**FINAL ENGINEERING PLANS  
FOR  
SUMMIT HOUSING GROUP - PUBLIC IMPROVEMENTS**

LYONS VALLEY PARK FILING NO. 8

**COVER SHEET  
SUMMIT HOUSING GROUP  
LYONS VALLEY PARK FILING NO. 8  
LYONS, COLORADO**

WATER PLAN AND PROFILE  
SUMMIT HOUSING GROUP  
LYONS VALLEY PARK FILING NO. 8  
LYONS, COLORADO

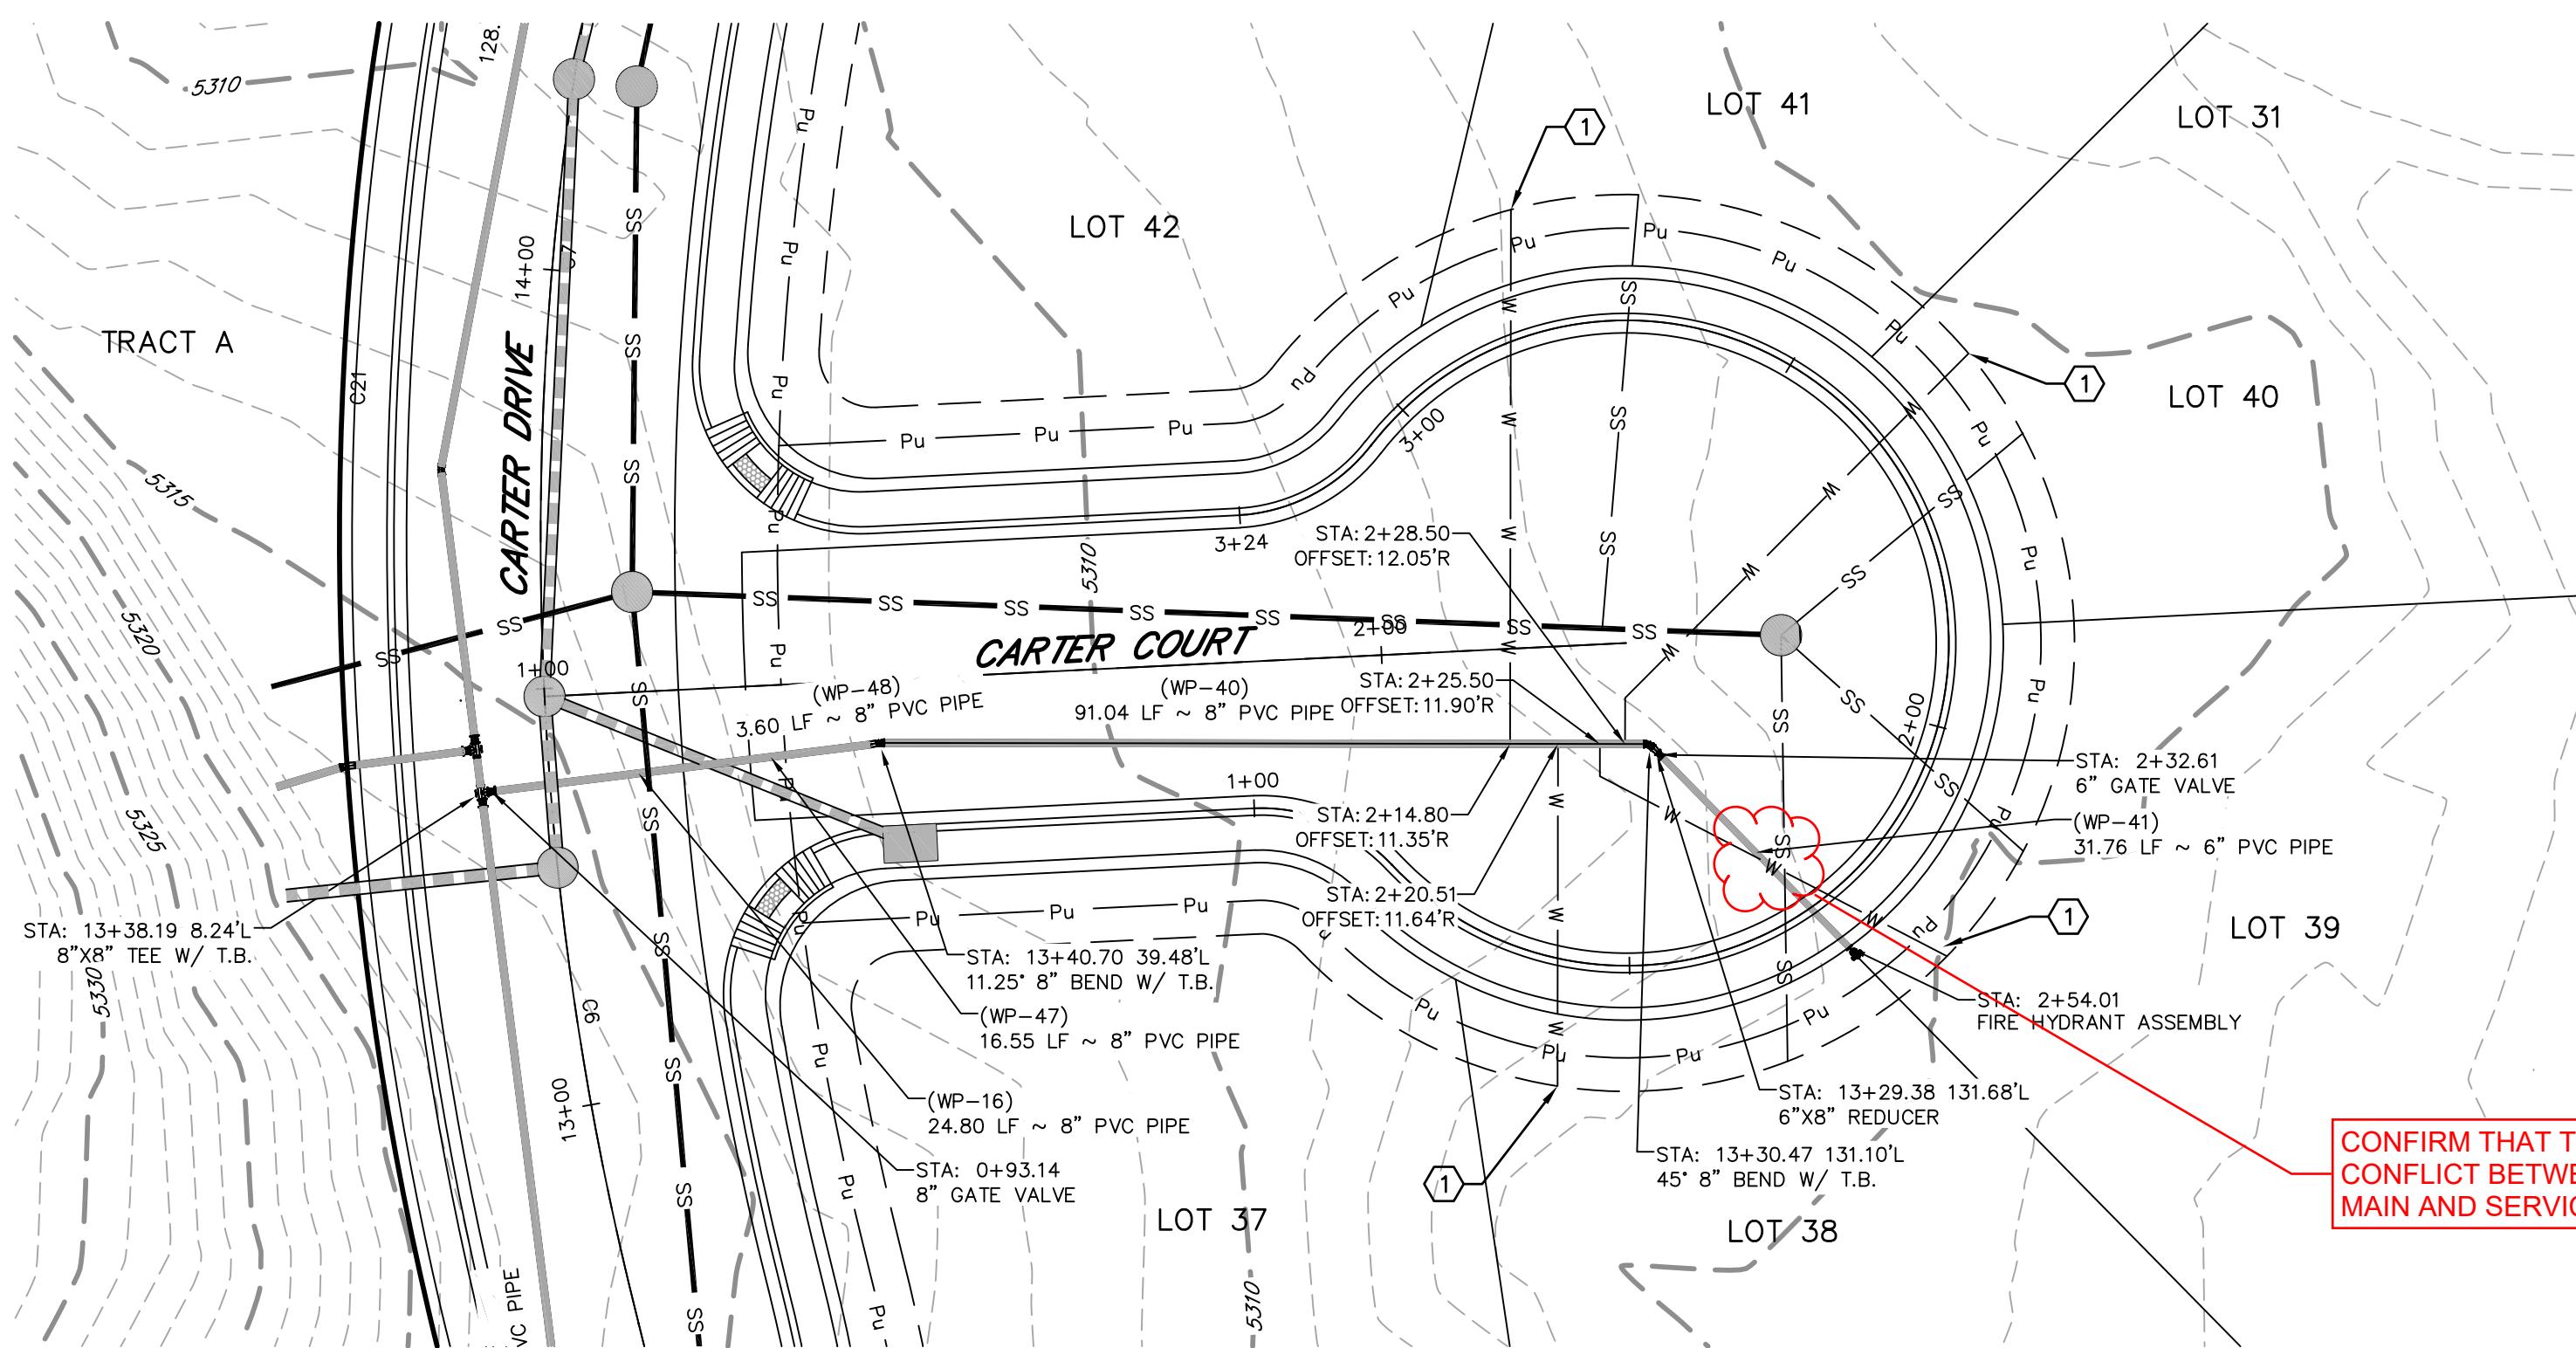
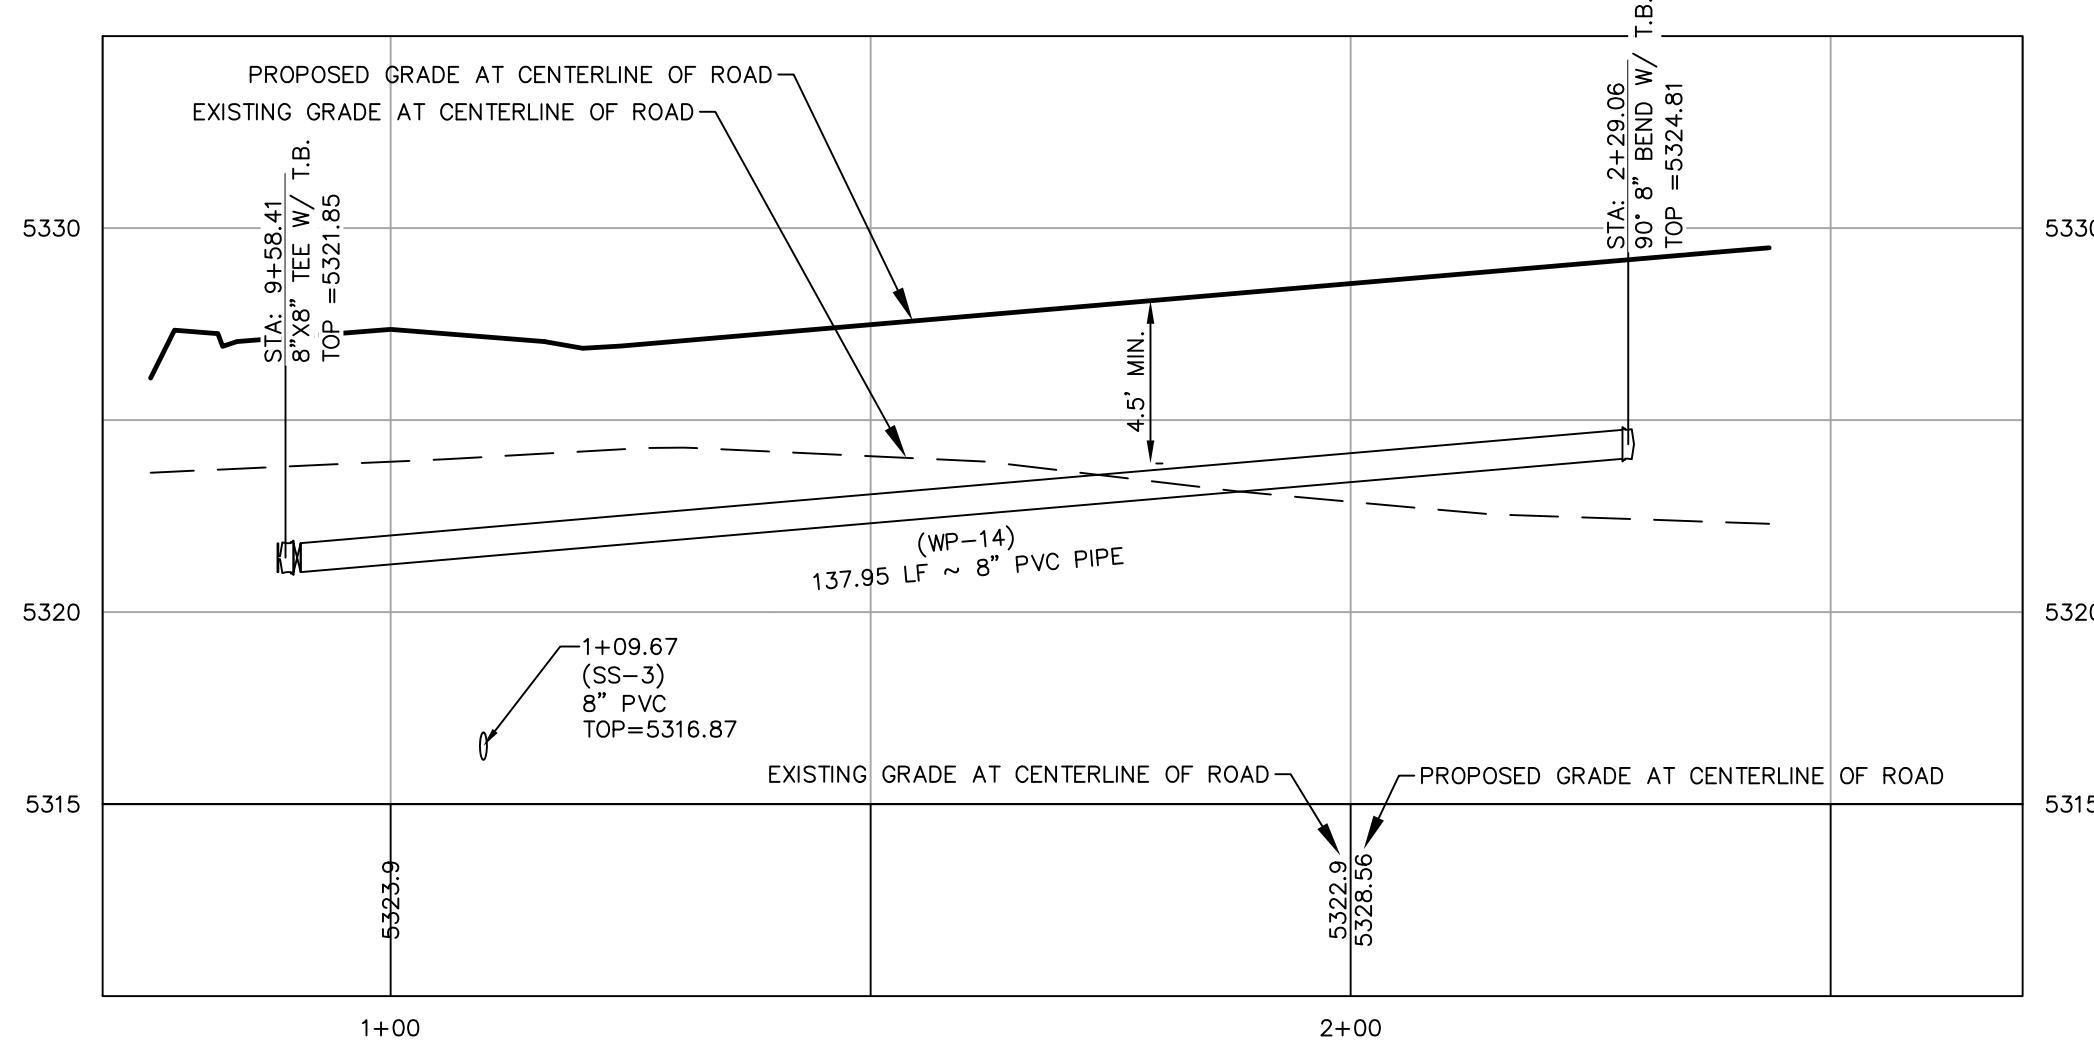
THIS IS THE WRONG PROFILE FOR THE PLAN VIEW ON THIS SHEET.  
PLEASE UPDATE TO INCLUDE PROFILE OF PIPES WP-16, WP-48, WP-40,  
AND WP-41. PROFILE SHOULD INCLUDE THREE UTILITY CROSSINGS.
